RE: Port Phoenix Water Way Marina – DCI2023-00054 – Major PD

Please find below responses and commentary to the provided comments from staff in your February 12, 2024 letter regarding the Commercial Planned Development application for Port Phoenix Water Way Marina (DCI2021-00054).

MASTER CONCEPT PLAN
FOR
PORT PHOENIX
SAFE HARBOR MARINAS
LEE COUNTY, FLORIDA

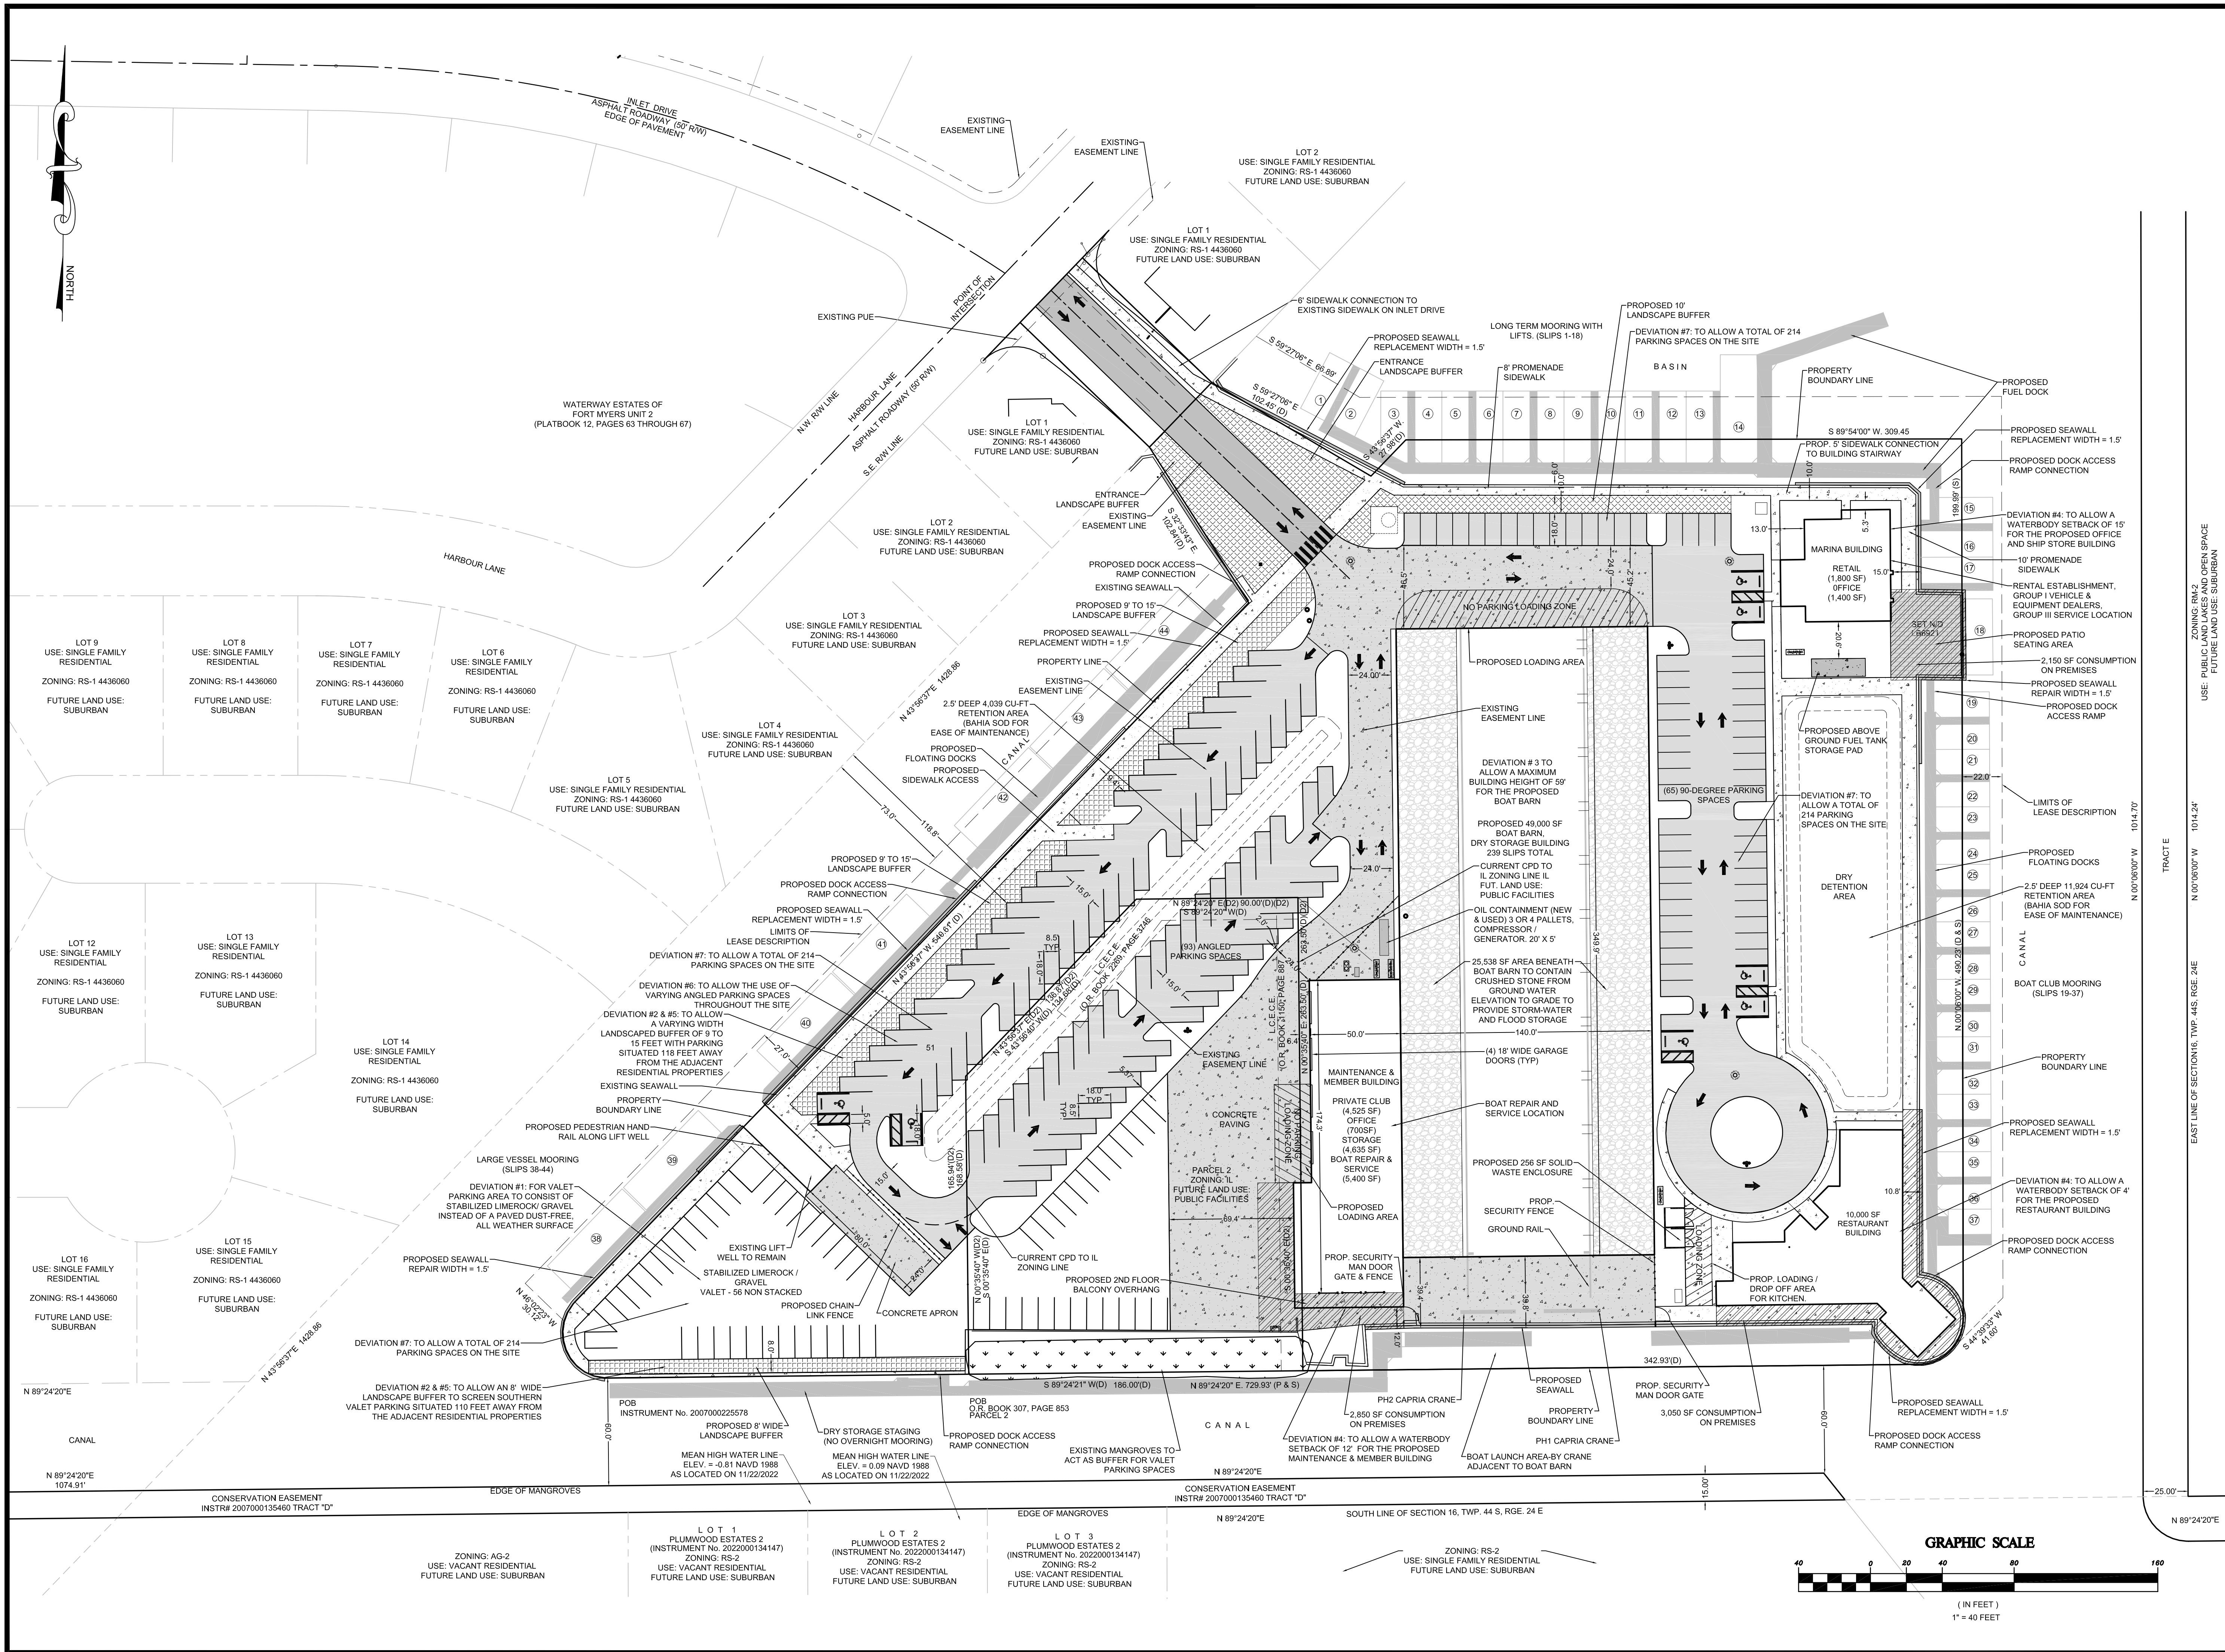
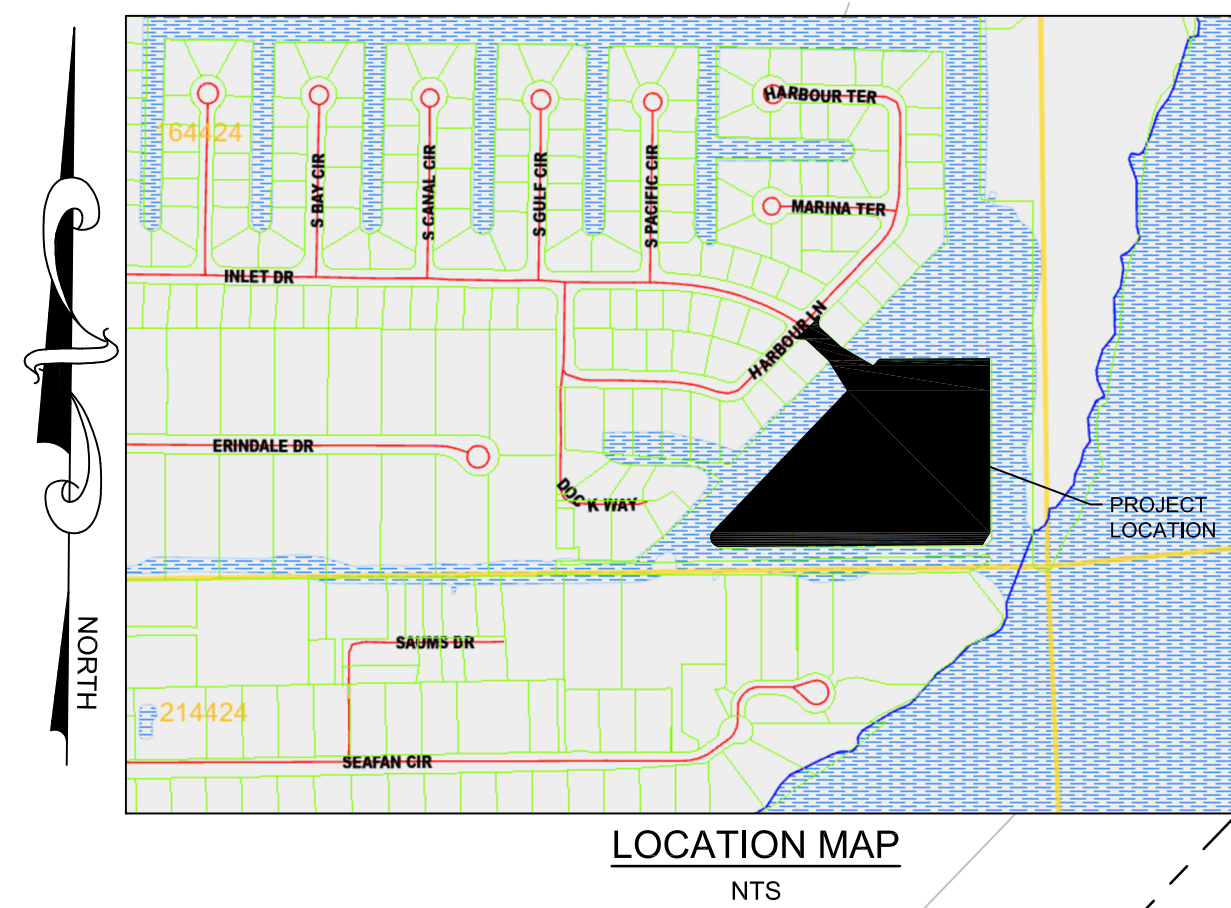
1. REPEAT COMMENT: LDC 34-373(6)(a) The location and explanation of all existing easements, whether or not those easements are recorded. If an easement is based upon a recorded document, the official records book reference must be stated. Public records show all existing easement on the site. If the easement has been vacated or released, please provide the associated documentation.

- The MCP has been revised to show the existing easements but does not include the required recording information. Please revised the MCP to include the recording information.*

3. Please revise the MCP to show the residential zoning and uses abutting the southwest portion of the site across from the existing lift well.

5. The Application, Property Development Regulations Table, and several other places state there will be 45 wet slips, but the Manatee Plan Summary only allows for 44 wet slips and the MCP depicts 44 wet slips. Please revise the Property Development Regulations table to be consistent with the MCP and provided Manatee Plan Summary.

The MCP has been revised to depict the proper recording information for the easements that have not been vacated. Please note that since the previous application, multiple unnecessary easements within the property have been vacated and removed from the MCP.

The MCP has been revised to depict the usage and zoning of the adjacent lots across from the lift well.

Tract D has been added to the MCP and all relevant documentation.
